**E12-17-004 GEn
ERR Report Status
Aug 6, 2019**

Brad Sawatzky

E12-17-004 GEn ERR Charge (Summarized)

GEn ERR date: May 29, 2019

2 Run Plan

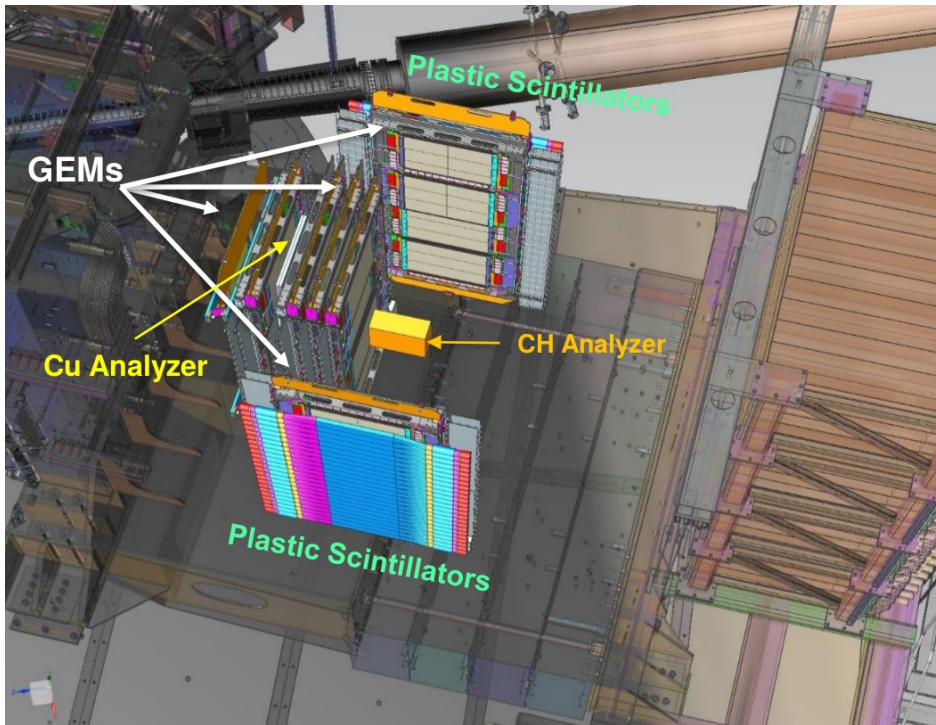
- Obtain a written agreement with the E12-09-019 which includes a high-level schedule showing how installation and deinstallation of all experiment hardware interleave with the run plans of the two experiments.

E12-17-004 has been approved for 120 PAC hours, or a nominal 10 calendar days at the typically assumed 50% efficiency. Of those 120 PAC hours, 12 PAC hours (or a nominal 3 calendar shifts) have been allocated to overhead associated with G_E^n -related configuration changes.

1. G_M^n Begin G_M^n production with kin X, Y, Z at angles a, b, c.
 - Final kinematic in this subset will match the G_E^n $Q^2 = 4.5(\text{GeV}/c)^2$ configuration.
2. Install the GEn specific components **(nominal 1 shift)**
 - Install shielding in the beamline dipole cutout (if this is not already in-place).
 - Install field clamp.
 - Install Copper analyzer plate.
 - Install Glasgow analyzer as needed.

3. Run GEn measurement **(96 PAC hours; 9 calendar days)**
4. De-install GEn components **(nominal 1 shift)**
 - Remove field clamp (Techs, crane).
 - Remove Copper analyzer plate (Techs, crane).
 - Remove Glasgow analyzer (Collaboration).
 - Disconnect cables from the beamline side (left) Recoil Proton detector assembly (Collaboration).
 - Remove beamline side (left) Recoil Proton detector from SBS stand (Techs, crane).
 - The right-side RP detector can remain or be craned off as desired.
